# 1963 - 1964 Corvette: Service News: Air Conditioning Changes

**Model and Year:** 1963 - 1964 Corvette

**Source:** Chevrolet Service News

**Date:** March 1964 - Volume 36 - Number 3

*Fig. 1—Rework of Blower Motor Circuit*

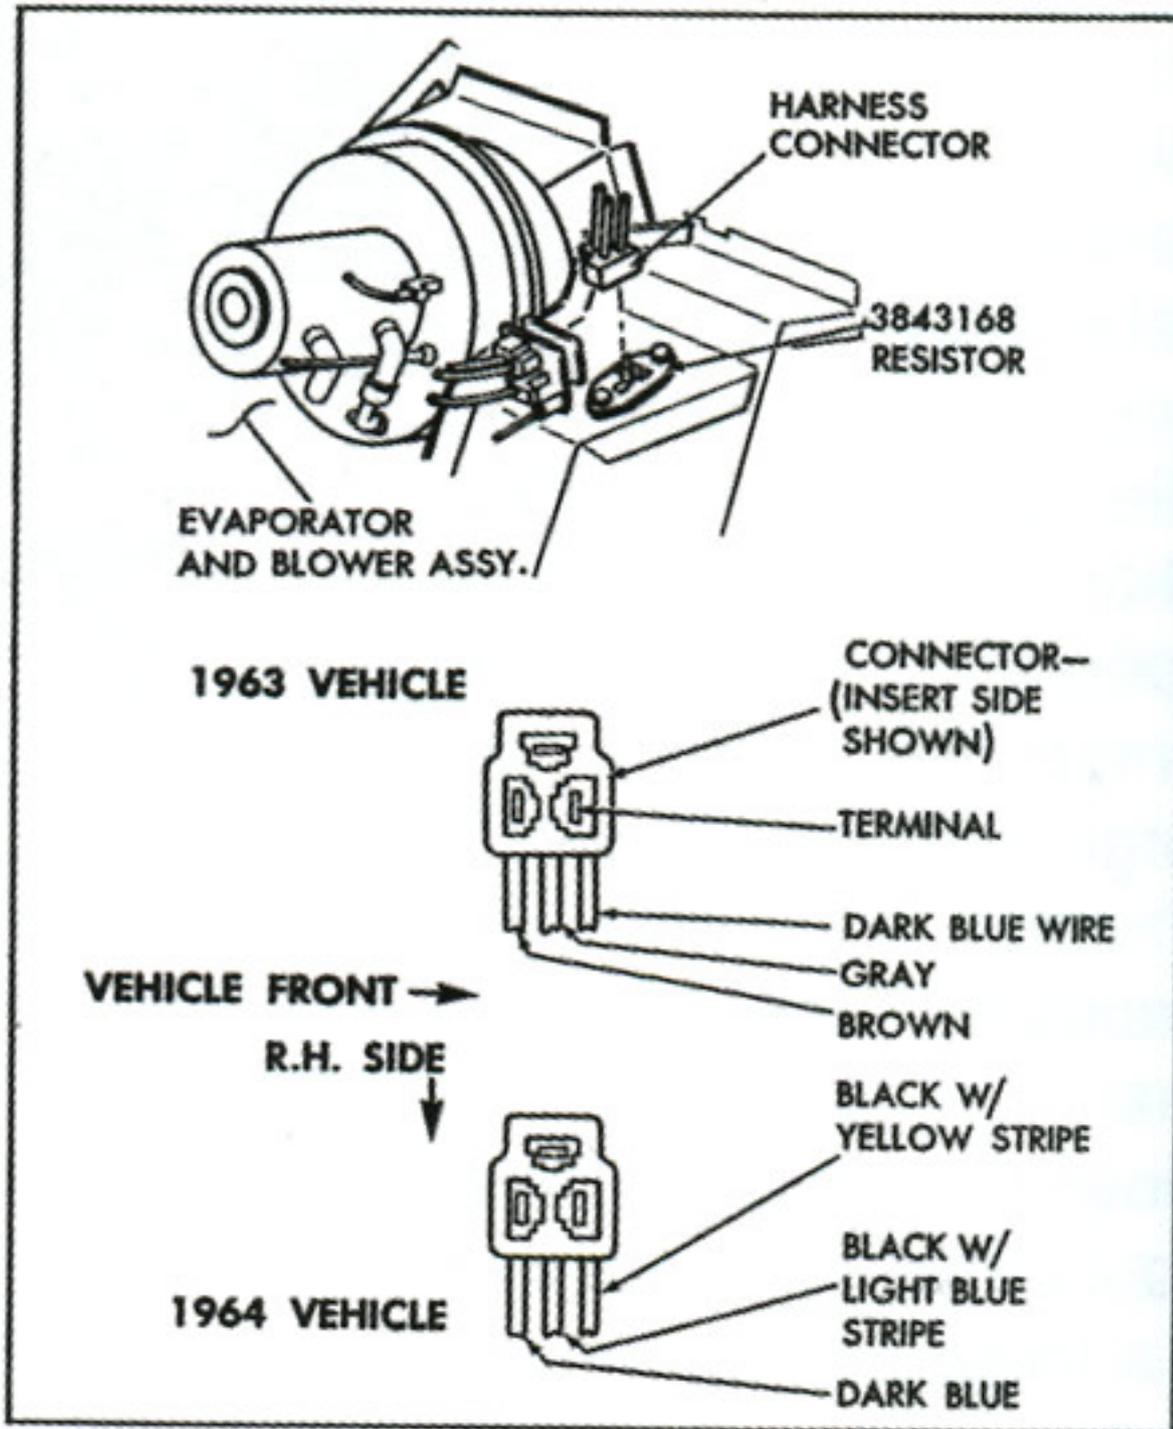
On all 1963 and early 1964 Corvettes equipped with Air Conditioner RPO C60, it would be necessary to slightly modify the electrical circuit to provide a true medium blower speed for the heater. In these RPO C60 installations, the resistor that was used in the blower motor circuit to establish blower medium and low speeds, unfortunately, during heater operation provides blower "low" RPM at the MEDIUM as well as at the LOW speed setting of the operator's control lever.

A wiring change introduced in Production averted the above problem on vehicles built later than December 16, 1963.

To provide the desired medium blower speed, on the earlier production units, proceed as follows:

1. Replace the installed blower motor resistor with Resistor Part No. 3843168.
2. Reverse the location of two leads in the multiple connector that plugs into the blower motor resistor assembly; reinstalling the color coded leads in the connector body at the locations show in Fig. 1.

NOTE: To remove the terminals from the connector body, insert a small screwdriver along the inboard side of the terminal and move the end of the screwdriver outboard to disengage the terminal from the locking ledge in the connector. Before reinstalling the terminals in the connector, spread the

terminals to insure that they lock securely when installed.
